Vermont Agency of Transportation
RECEIVED
MARLBORO BRF 010-1 (43) - TEMPORARY TRAFFIC BYPASS 4-3-14-A.pdf

PLAN OF TEMPORARY BRIDGE, ABUTMENTS & BYPASS ROAD
BRF 010-1(43)
ROUTE 9
MARLBORO, VT

PLAN AND PROFILE OF TEMPORARY BRIDGE, ABUTMENTS & BYPASS ROAD

DETAILS: TEMPORARY BRIDGE

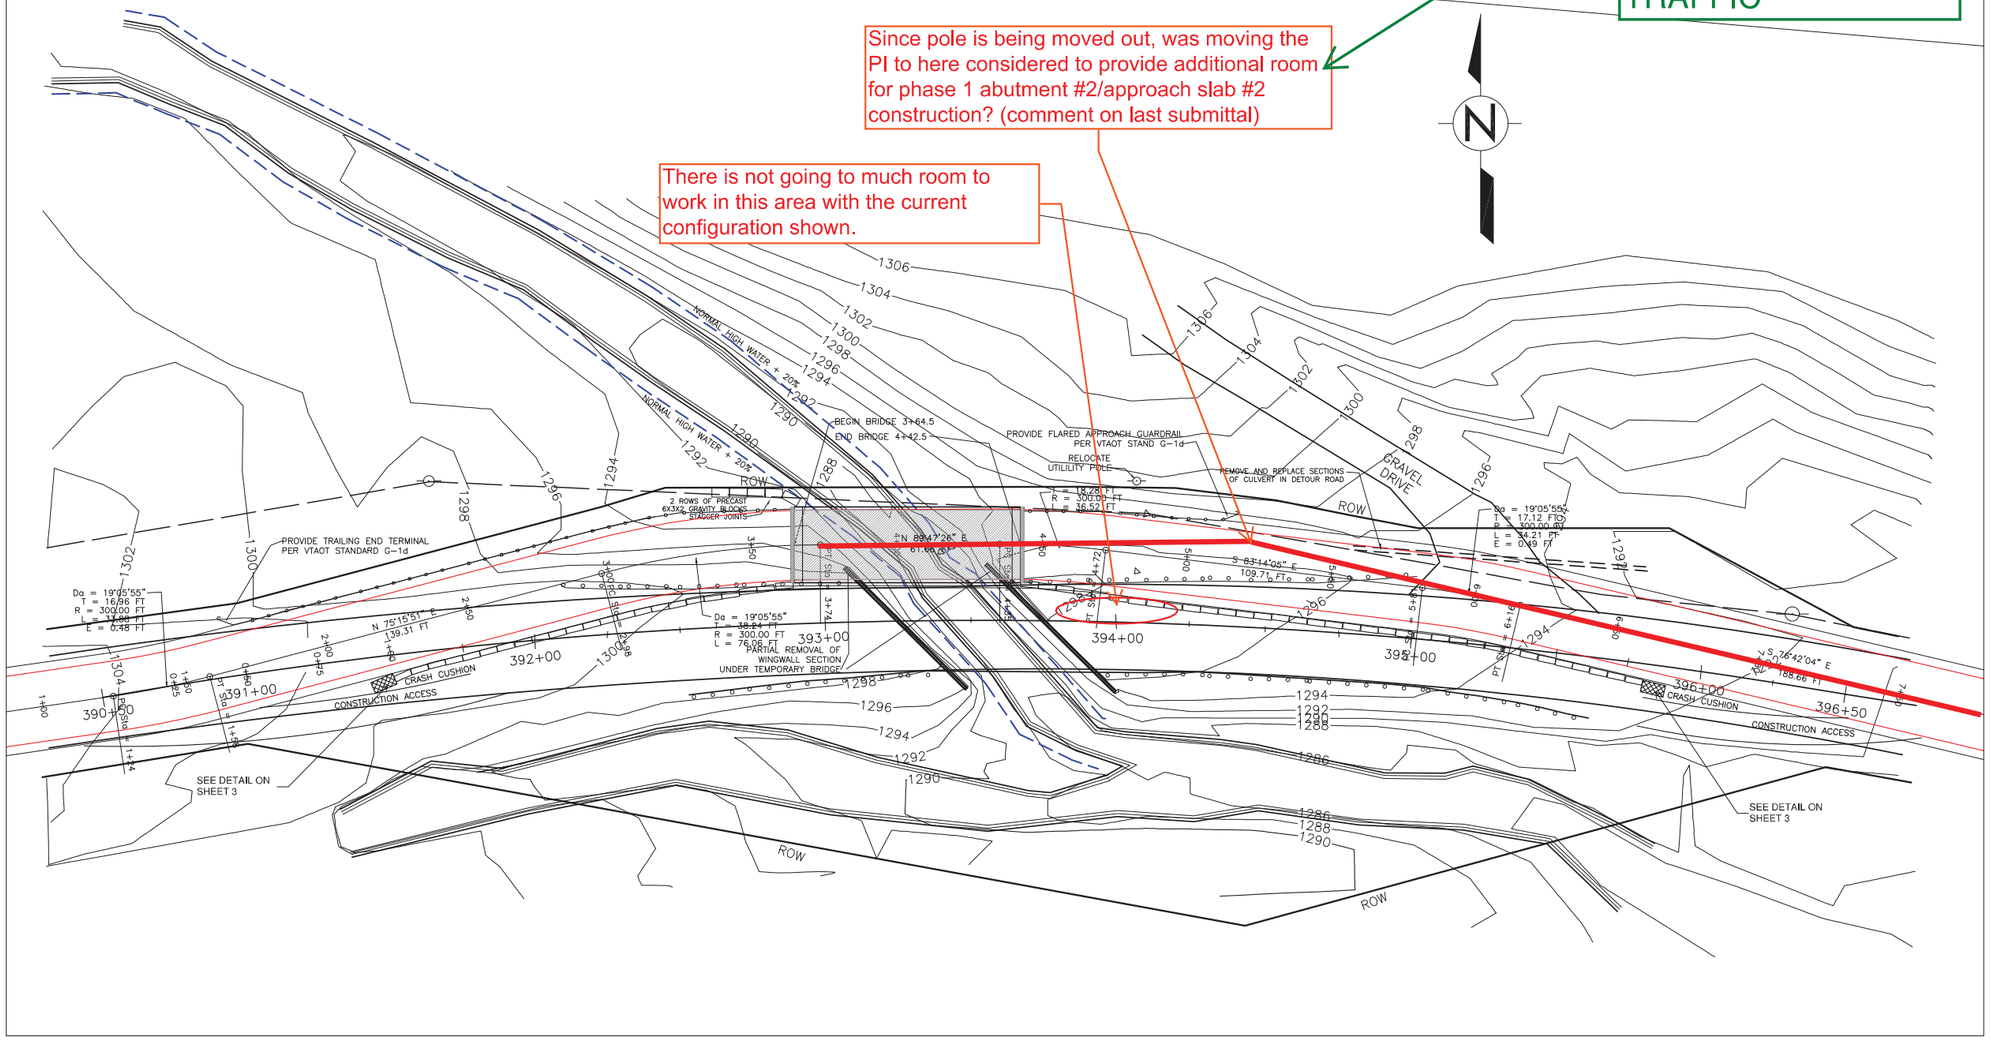
Since pole is being moved out, was moving the PI to here considered to provide additional room for phase 1 abutment #2/approach slab #2 construction? (comment on last submittal)

There is not going to much room to work in this area with the current configuration shown.

COMMENT NOTED.
A RECORD PLAN
WILL BE SUBMITTED
PRIOR TO
TRANSFERING
TRAFFIC

ABUTMENT DETAILS 1" = 2'

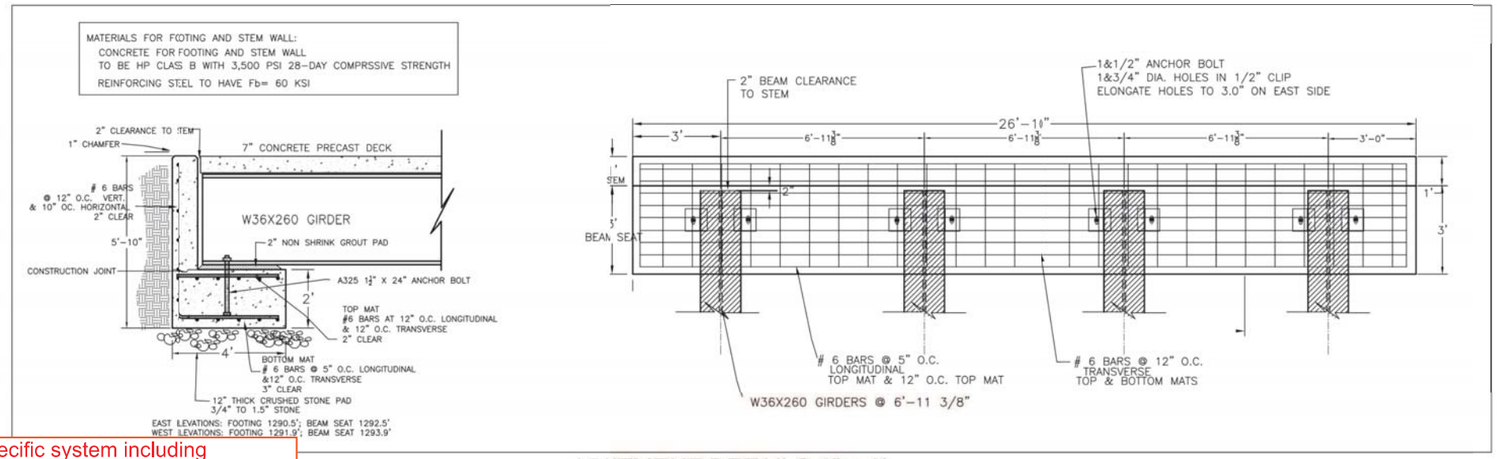
Provide details on specific system including manufacturer and product name, dimensions between barrels and dimensions from concrete barrier so it can be properly installed.

SEE CRASH GARD MANUAL SECTION "Recommended Installation Procedure"
